Sumter City-County Planning Commission

SD-25-03, 1991 Stamey Livestock Rd. – Triplecrown at The Village - (City)

III. PRELIMINARY PLAT REVIEW

The following review is based upon the preliminary plan submission titled, “*The Village Subdivision, Triplecrown Phase F1*”, prepared by Michael E. Weatherly, P.E. Consulting Environmental and Civil Engineer, last revised November 6, 2025.

Figure 1 - "The Village" General Development Plan Map

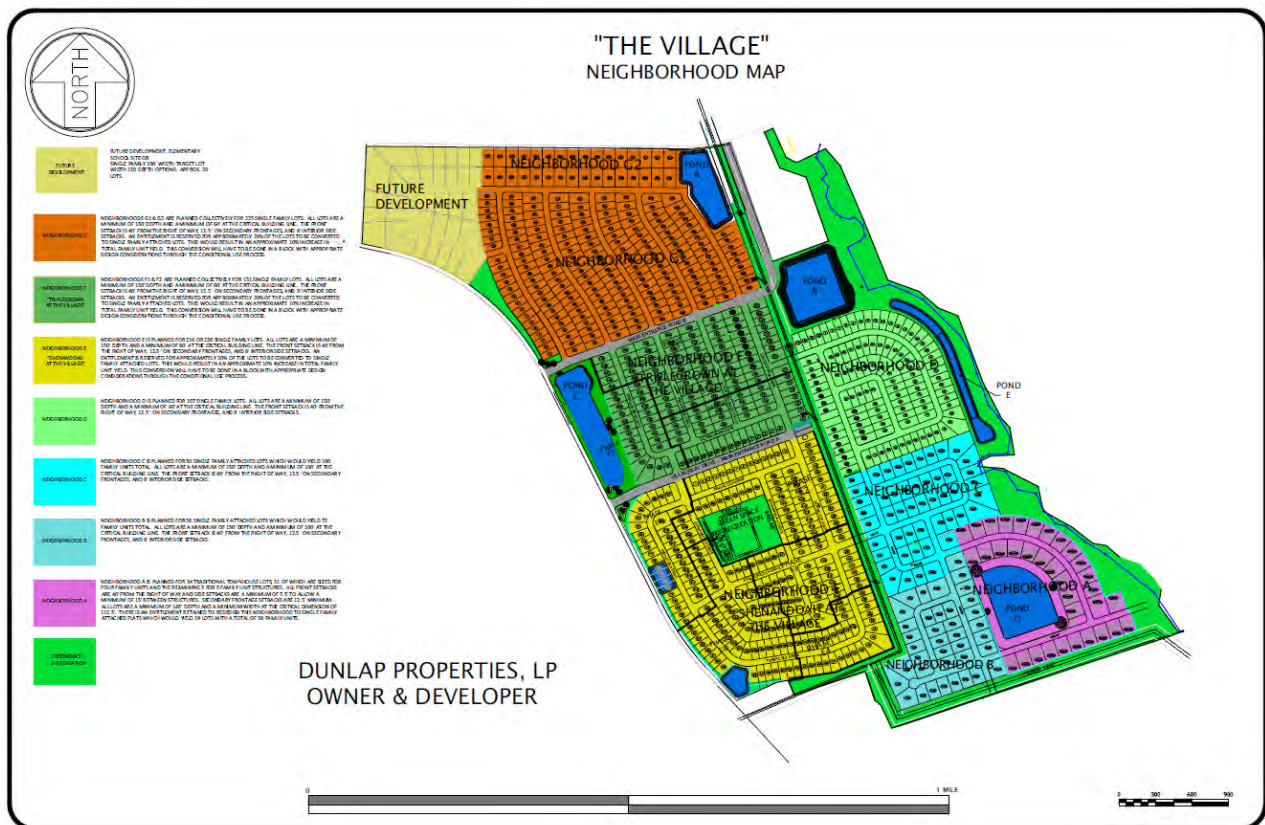
Each proposed neighborhood in the development must align to the 7 neighborhoods as identified in the General Development Plan. Each neighborhood may have phasing for development of utilities, stormwater management, and associated infrastructure, but sub-phases cannot cross the boundaries of the neighborhoods.

The lot count for Triplecrown at The Village (“Neighborhood F”) as specified in the approved General Development Plan is 131. The submitted lot count is 139, which exceeds the approved total by 8 lots. The Planning Commission may approve the subdivision at the lot/unit count proposed, however, 8 units must be deducted from other neighborhood(s) in the development to maintain the maximum unit count of 991 for the entire GDP. Alternatively, the developer may

submit a GDP revision application, to be considered by the Planning Commission as an independent request.

Above: Subdivision Layout Graphic with Phasing

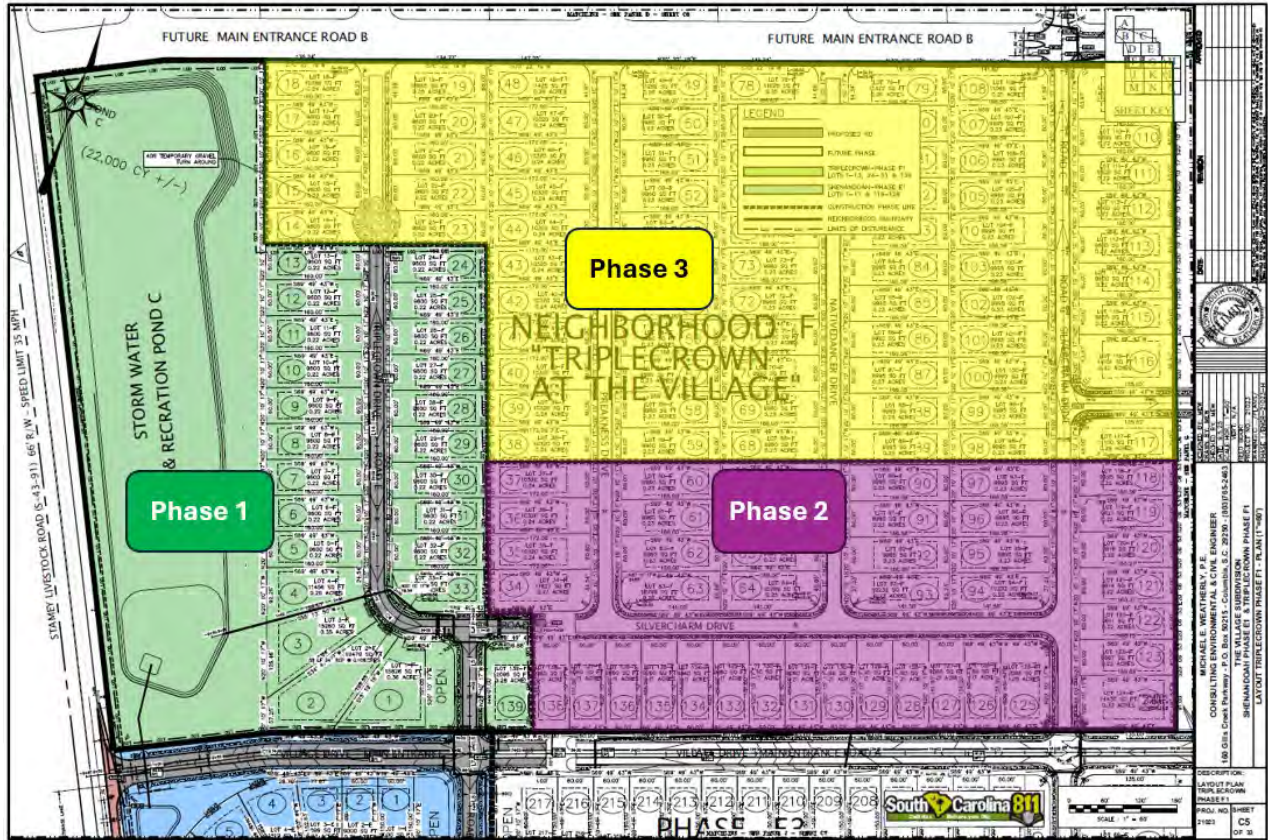
The Triplecrown at The Village subdivision is proposed to be developed in 3 phases. Phase 1 consists of 24 lots on a portion of Triplecrown Dr. Phase 2 consists of 41 lots on portions of Silvercharm Dr., Preakness Dr., and Nativedancer Dr., and Phase 3 consists of 74 lots on portions of Triplecrown Dr., Preakness Dr., Nativedancer Dr., and Silvercharm Dr.

A staff recommended condition of approval is that prior to final plat approval for any lots in Phase 2 of the subdivision, secondary vehicle access supporting at least the needs of emergency services must be established. Prior to final plat approval for any lots in Phase 3, the planned main entrance road B as shown on the plat must be installed to provide secondary access to the subdivision.

Figure 3 - Triplecrown at The Village, Phase 1 Landscaping Plan and Planting Schedule

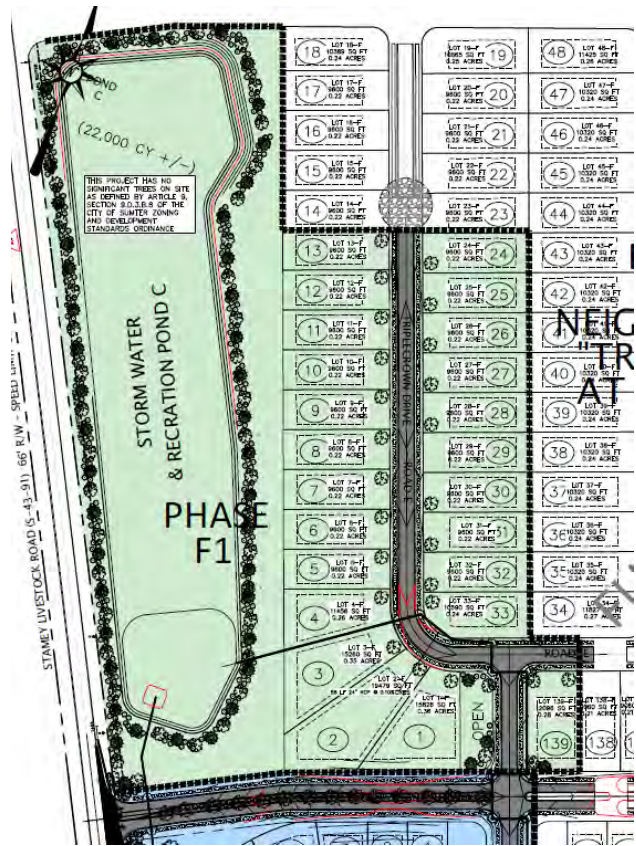
The existing site for the proposed Triplecrown at The Village subdivision is primarily open, with no significant or historic trees present. Street and stormwater landscape buffer areas have been identified on submitted plans. However, detailed landscaping plans for phases 2 and 3 have not been submitted at this time. Submission and staff approval of these plans is required prior to final plat approval for each subsequent phase.

1 street canopy tree, 2 inch caliper and 7 ft. in height, is required for each unit/lot. Dwellings must also have sodded front yards. These items must be complete prior to certificate of occupancy issuance for each unit/lot. Additionally, grading and sodding of the identified community mailbox area (at least 15 ft back from edge of pavement) is included as a proposed condition of approval.

DESCRIPTION:
LAYOUT PLAN TRIPLECROWN PHASE F1
PROJ. NO. SHEET
21023 C5
OF 33

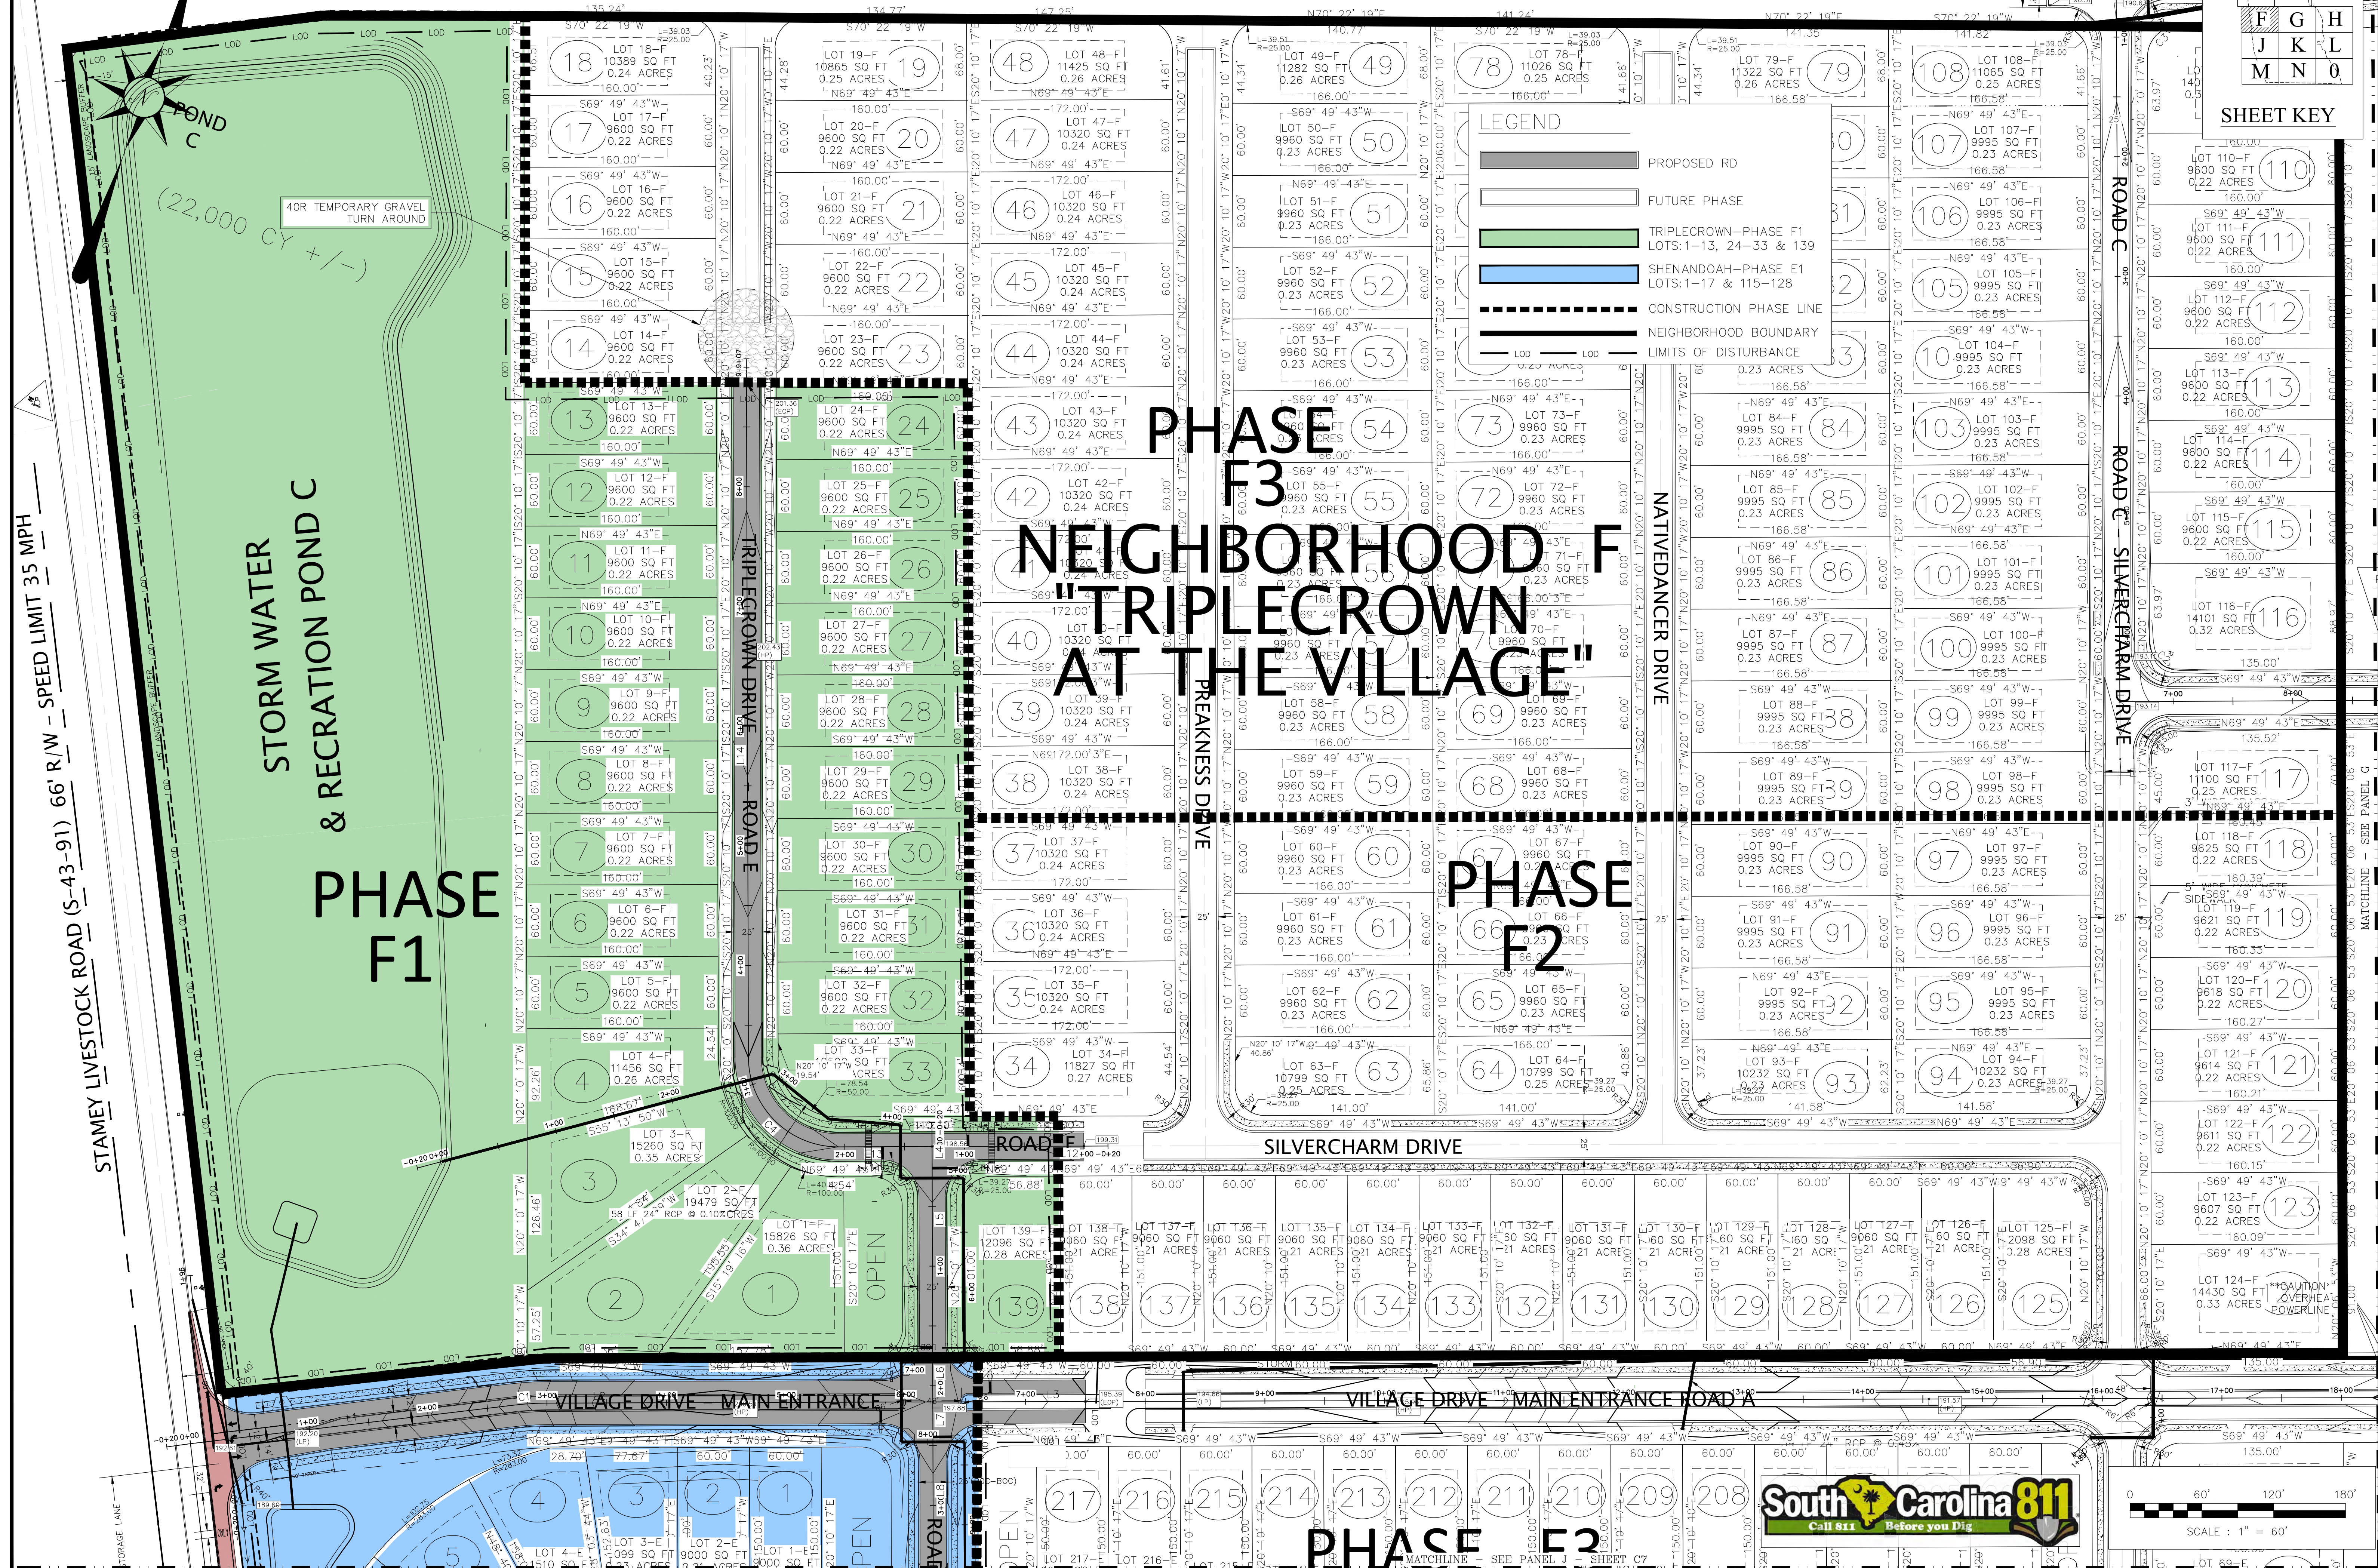
1. Provide planned subdivision entrance signage, both location of sign(s) and style of sign(s)
2. Submission of stormwater pond details, including total facility size for proposed pond.
3. Revise plans to show installation of minimum emergency services secondary access prior to Phase 2, and full construction of Main Entrance Road B prior to Phase 3.
4. Revise plans to show extension of water line on Stamey Livestock Rd. to the north side of Village Drive, or confirmation from Sumter Public Services that proposed water line installation plans are sufficient.
5. Provide copy of SCDOT encroachment plans detailing all proposed work within Stamey Livestock Rd. right-of-way.
